Interactive comment on “Flash flood occurrence and relation to the rainfall hazard in a highly urbanized area” by K. Papagiannaki et al.

ANSWERS TO REFEREE COMMENTS We would like to sincerely thank Martin Mergili and the anonymous referee for the constructive comments that helped us to improve the presentation and the overall argumentation and quality of our paper. Following the reviewers' comments and suggestions we proceeded to a careful revision of the article. In more detail, the following changes have been made in accordance with the respective comments:

Fig. 1. Figure 1. Map of target area and locations of surface meteorological stations. Stations are named by the municipalities they are located in.

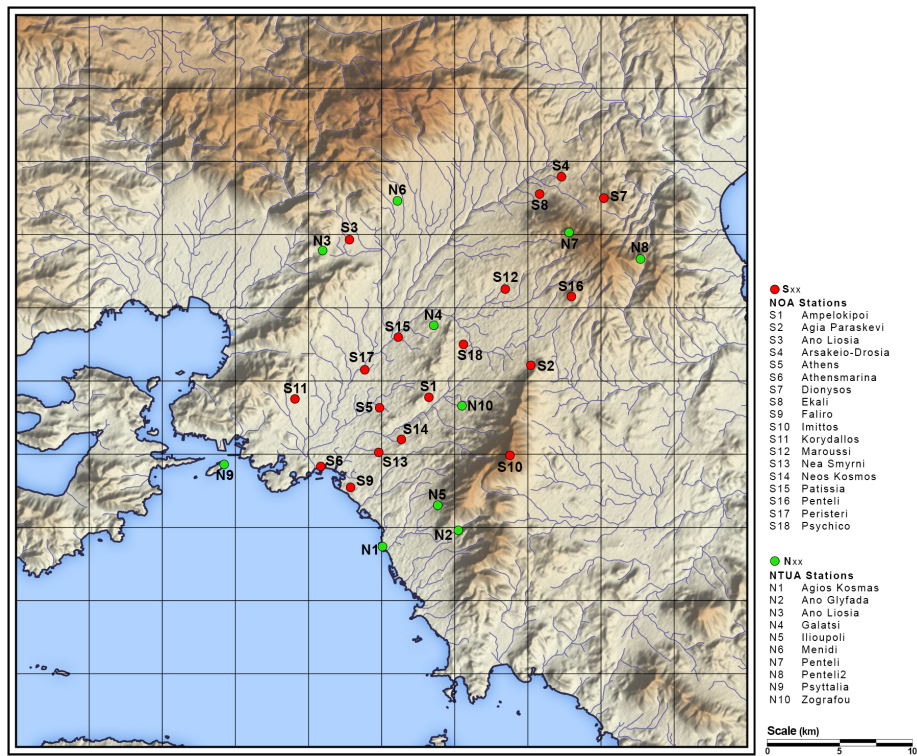
4. 'Figs. 1–3 need a scale bar (alternatively, you may mention the grid spacing)'

5. 'As the article concerns both natural and socio-economic issues, it would be good if you could add the most important towns (if possible, as areal signatures) to Fig. 1. Further, the green and red symbols should be shown also in the legend (even though it is clear what they mean)'

11. 'Figure 1. You could reduce the region presented in the figure and increase the size of the numbers and the corresponding stations. I am afraid it won't be clear for the readers'

Figures have been revised according to the suggestion.

Green and red symbols have been added in the legend as suggested. In what concerns the towns, we believe that a greater size of the picture would be required for a clear printing of the respective names. The legend of Fig.1 lists the meteorological stations, which are named by the municipality in which they are located. Therefore, we added in the caption an explanation about the origin of the stations' names. Main municipalities are also shown in Fig.2, in which, as explained in section 3 'Methodological issues': 'The name of each area derives from the respective municipality that covers the major part of it.'

The size of the number has been increased as suggested.

Fig. 3. Figure 3. a) Number of flash flood events per sub-area.

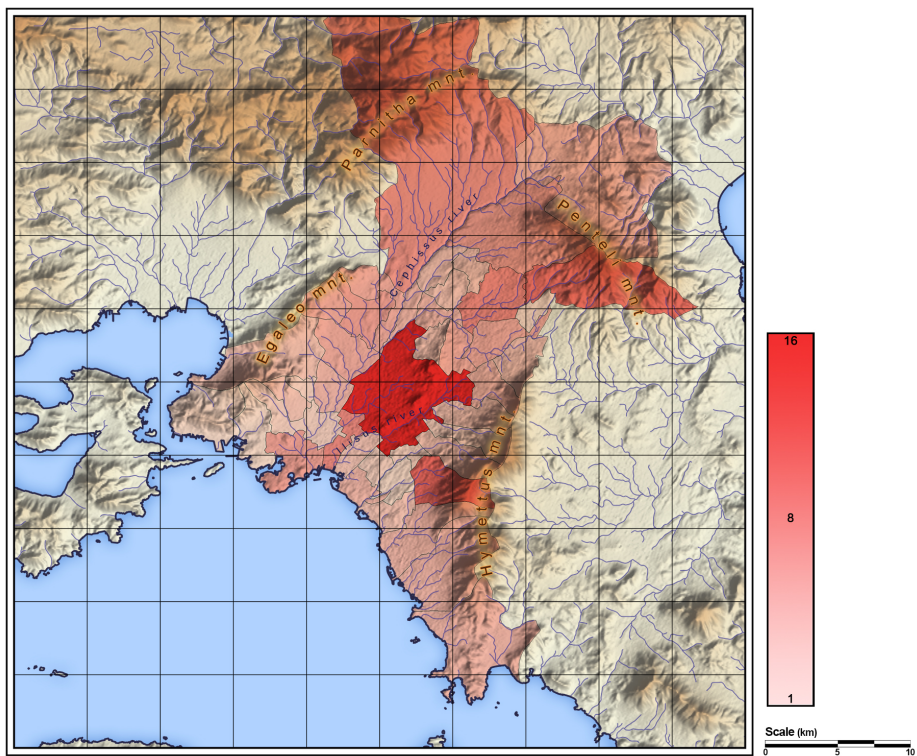
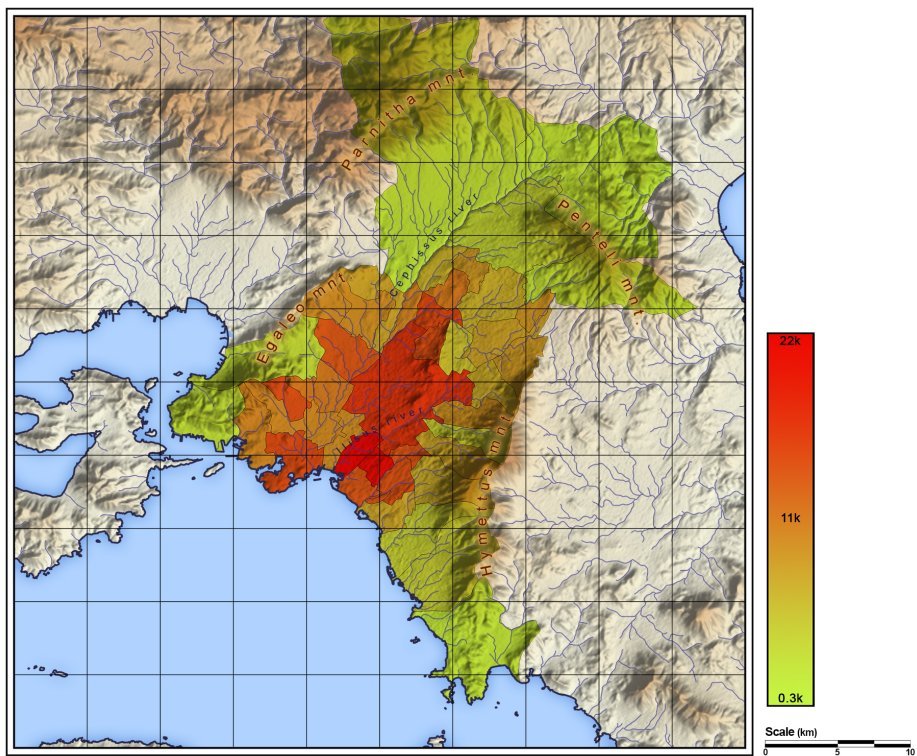
12. 'Figure 3 has not legend explaining the colours meaning.'

The caption of the figure has been revised.

Fig. 5. Figure 4. Quantile distribution plots for a) R24 and Fraction of data relates to the number of Fire Service operations.

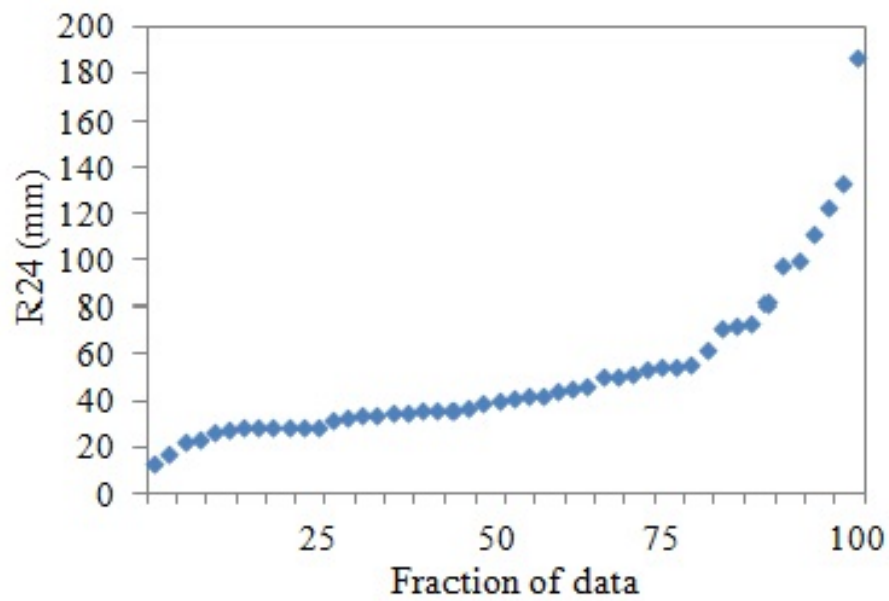
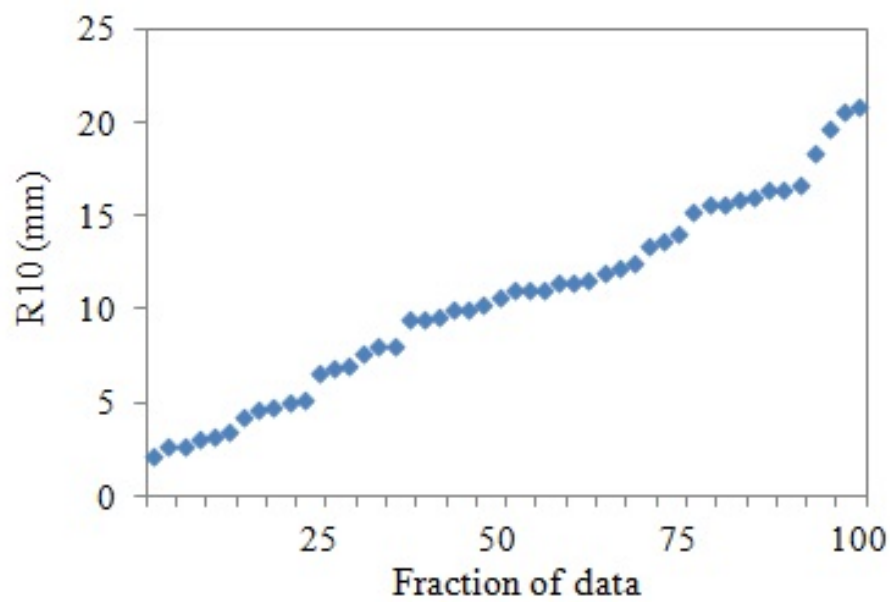
6. 'Fig. 4: I think that the y axis label of the right pane should be replaced by "R10"? In fact, the two figures look very similar, probably the right one has to be replaced by another one at all ... Further, you should write in the caption that the fraction of data relates to the fire brigade reports'

The reviewer correctly observed that the Fig.4b is the wrong one. We replaced it by the correct one. The caption has been also revised according to the suggestion.

Fig. 7. Figure 5. Number of events, Fire Service operations and average number of operations per event for various ranges of (a) 24-h (R24)

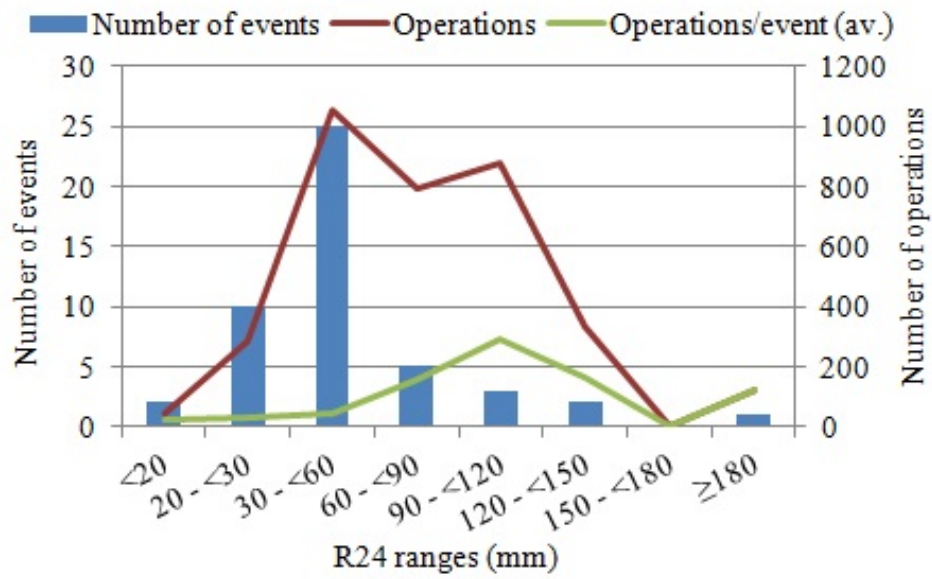
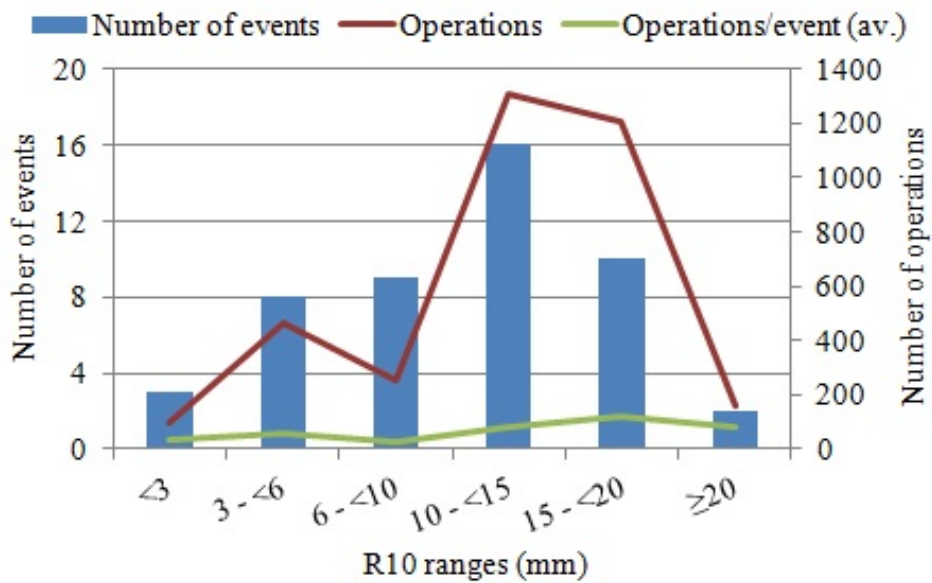
7. 'Fig. 5: Be careful, the x axis tick mark labelling is incorrect. E.g., R24 of 30 mm is actually assigned to two classes, this is not allowed. 30 – <60 mm, 60 – <90 mm etc. would be correct'

8. 'Figs. 5 and 6: It might be good to show a graph relating the number of events and the number of the fire brigade operations (e.g., building a ratio between the two). However, it is the decision of the authors whether they would like to try doing so.'

The figures have been corrected according to the suggestion.

The ratios operation/event for various ranges of 24-h (R24) and 10-min (R10) accumu-

lated rainfall is discussed in the text, section 4.1. Figures 5a,b have been revised to include the respective data, according to the suggestion.
